Town of Arlington, MA Redevelopment Board

Agenda & Meeting Notice September 9, 2024

2. Public Hearing: Docket #3816, 5-7 Belknap Street

3. Public Hearing: Docket #3633, 1500 Massachusetts Avenue

SITE PLAN DIAGRAM - 9/3/24 PARKING STUDY

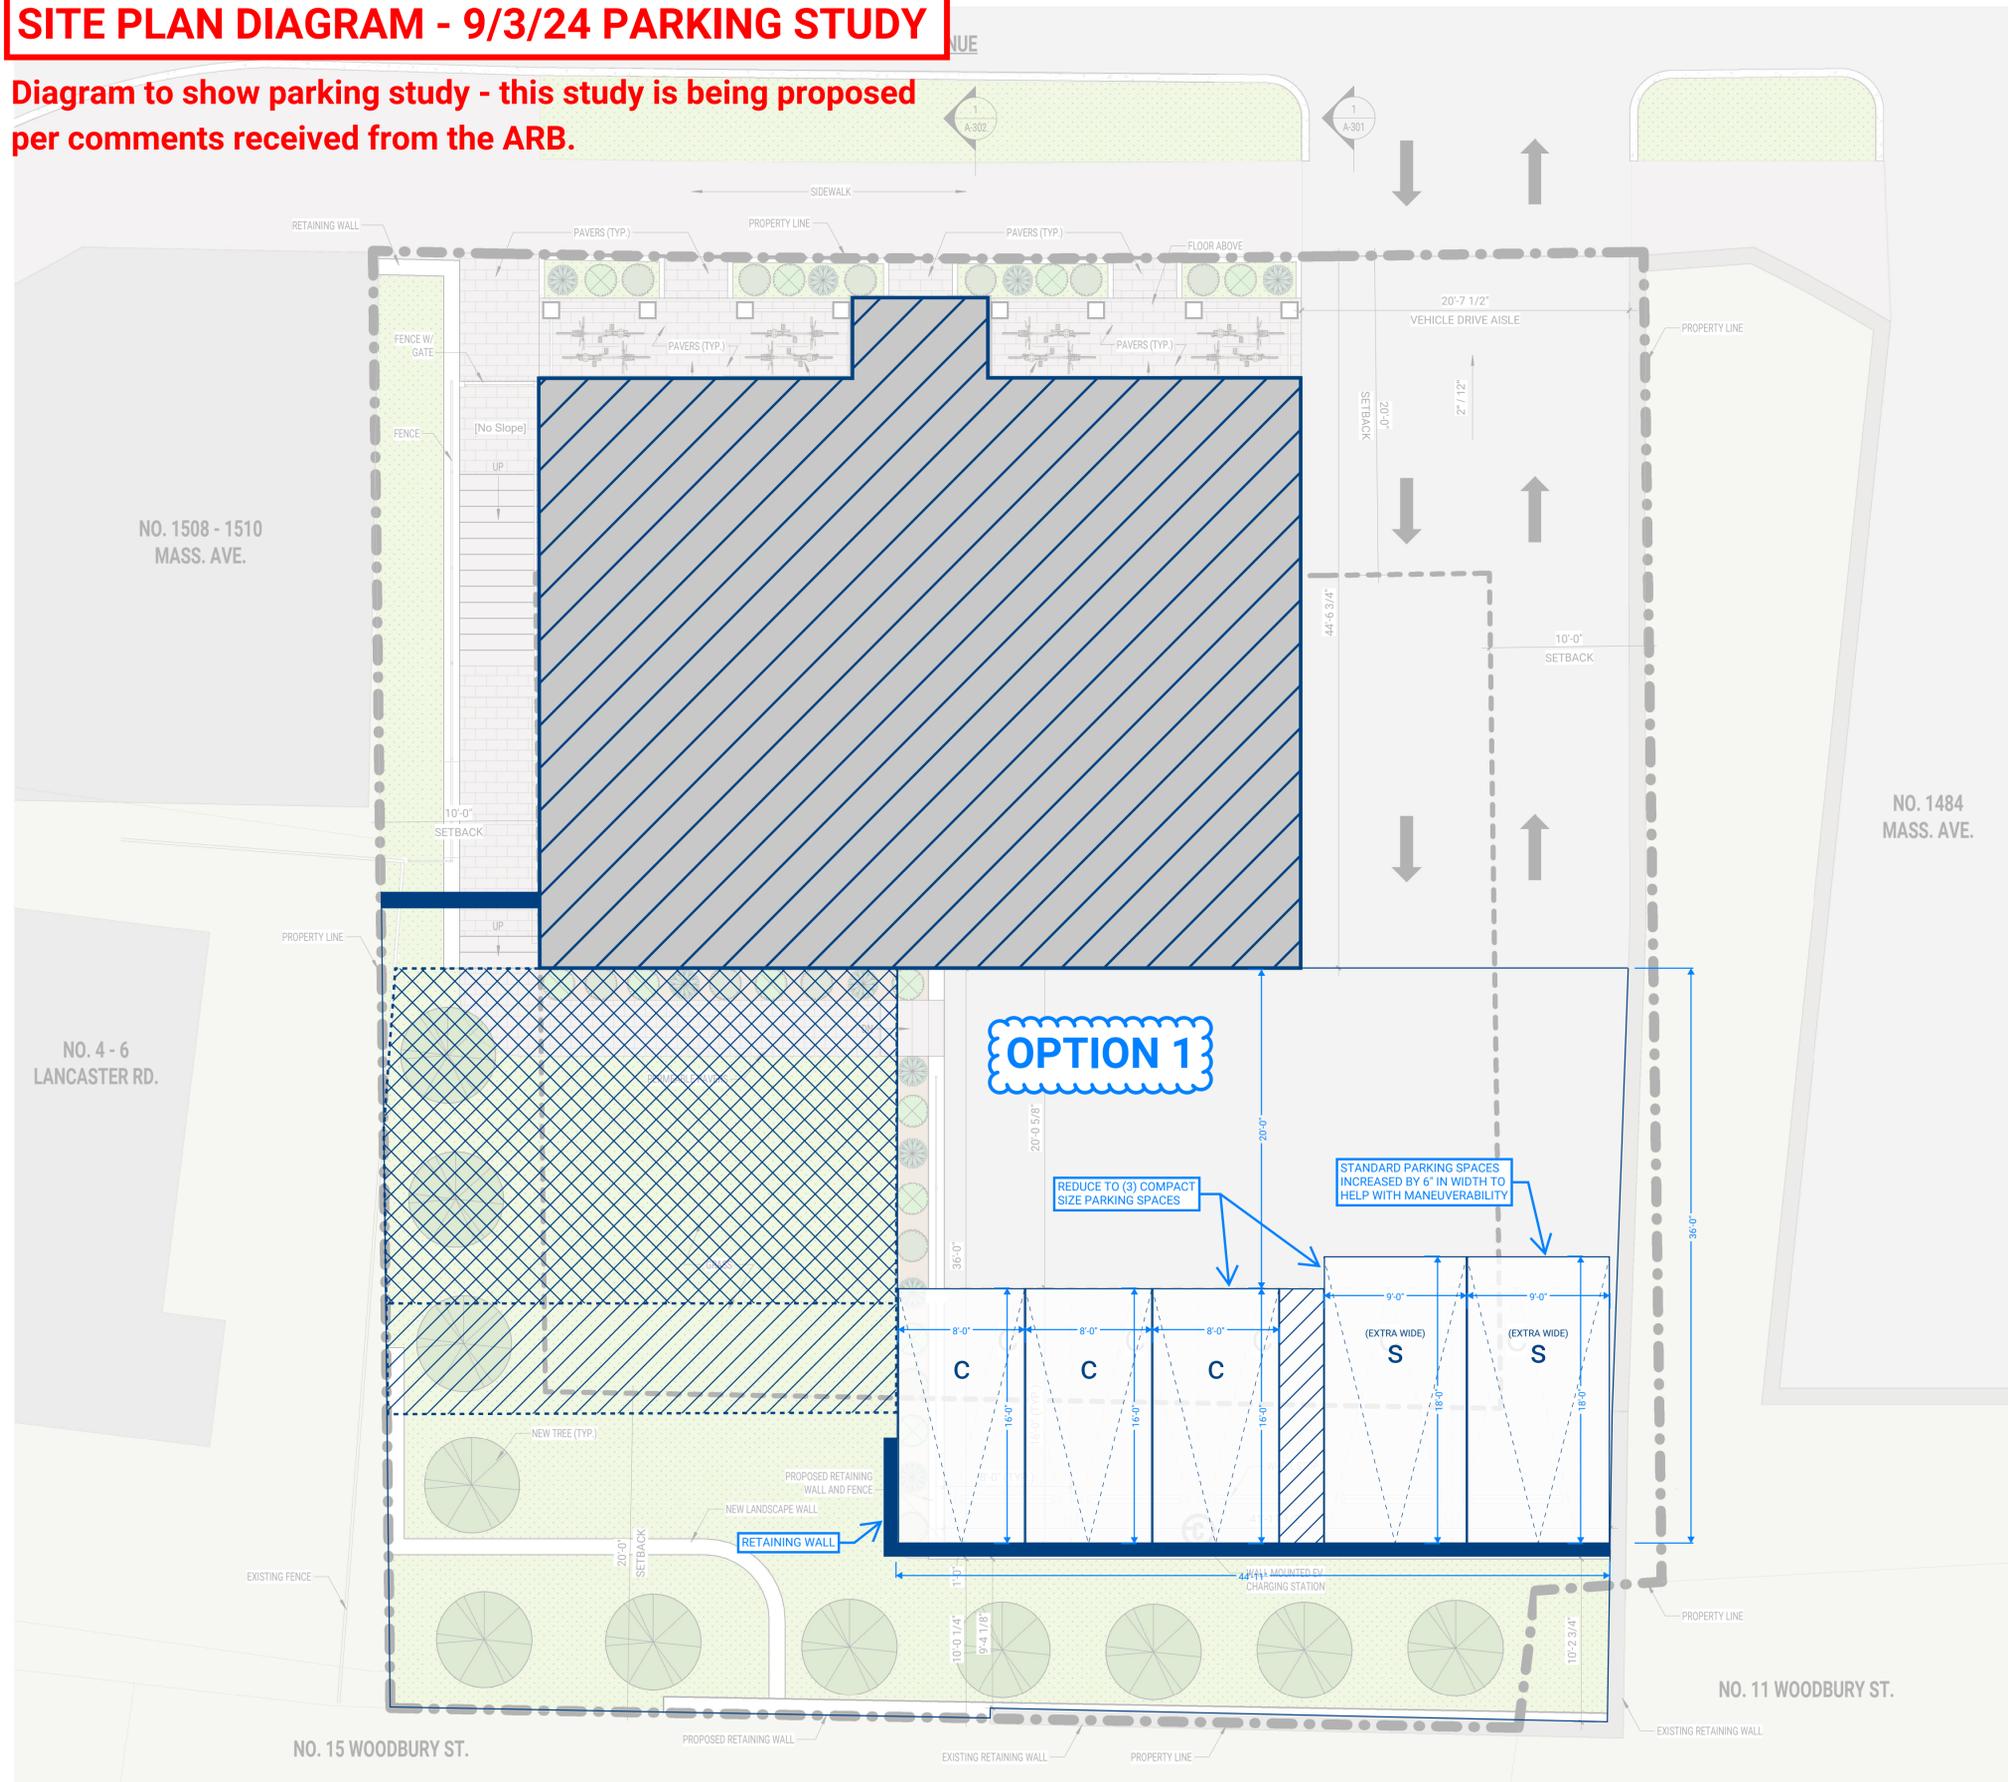
Diagram to show parking study - this study is being proposed per comments received from the ARB.

SITE PLAN DIAGRAM - 9/3/24 PARKING STUDY

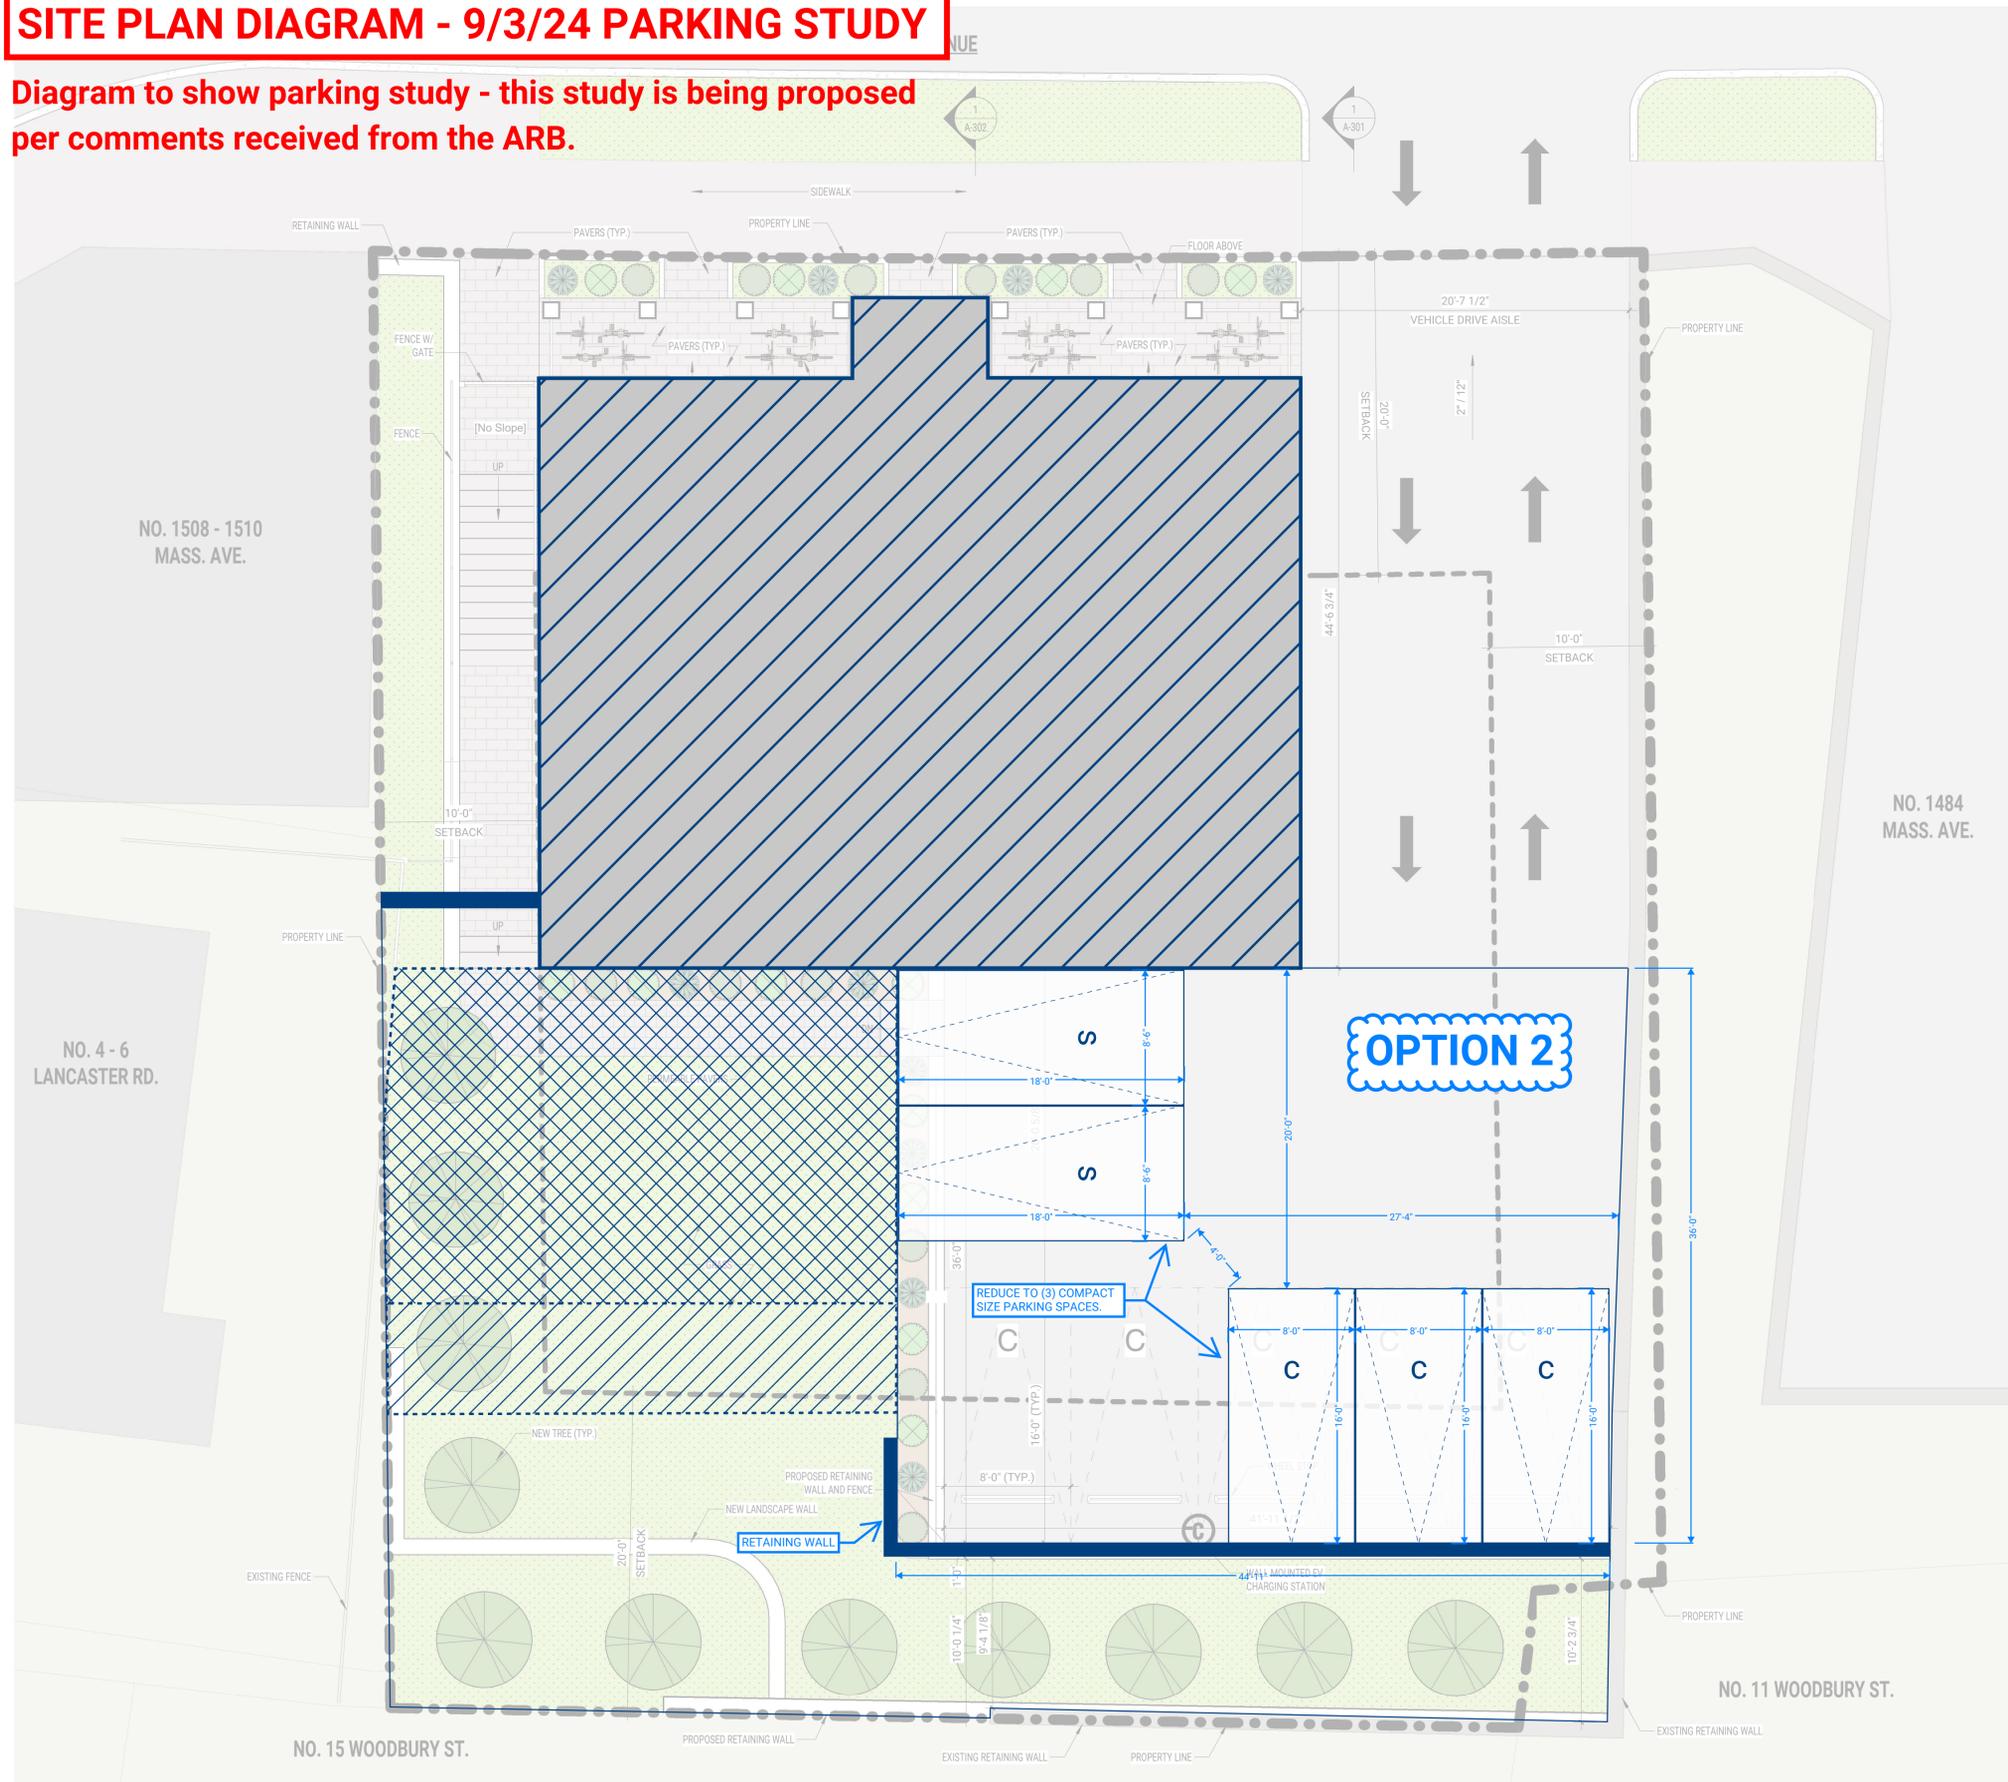
Diagram to show parking study - this study is being proposed per comments received from the ARB.
